SUBMISSION: SUTHERLAND

a written submission by way of further objection to DA 2020/1351

#I Bilambee Lane, Bilgola Plateau DA 2020 1351

WRITTEN SUBMISSION: LETTER OF OBJECTION

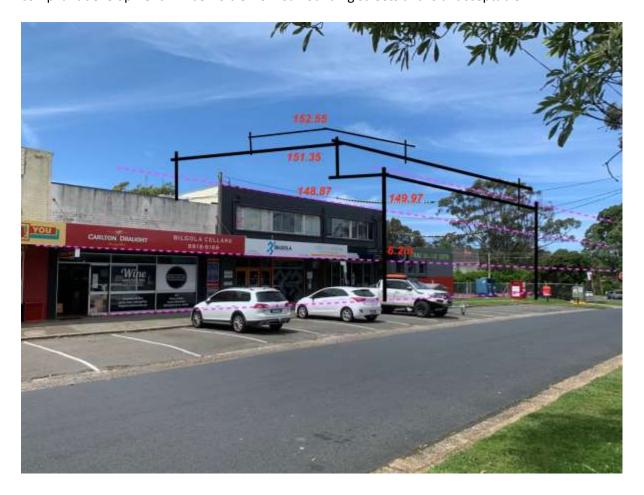
We bring to NBLPP attention the fact that the proposed development will completely close off all air, light, view, and solar access to the external private open space balcony of 3/1 Bilambee Ave Bilgola Plateau.

DCP D3.7 Side and rear building line

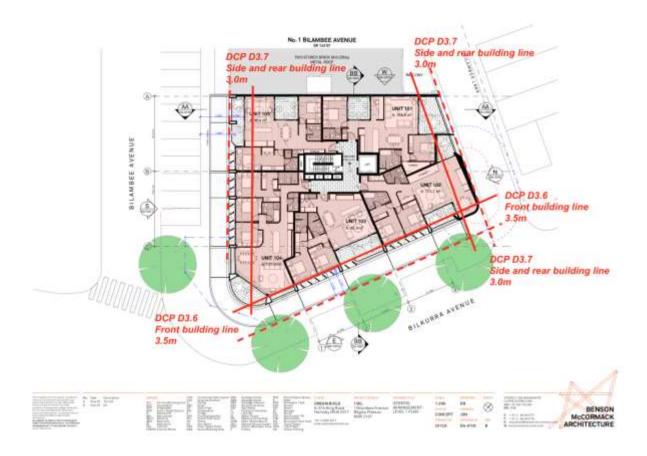
We ask that **DCP D3.7 Side and rear building line be added to the grounds of refusal.** We contend that the residential component of any development on the subject site, conform to the requirements of all setback and envelope controls.
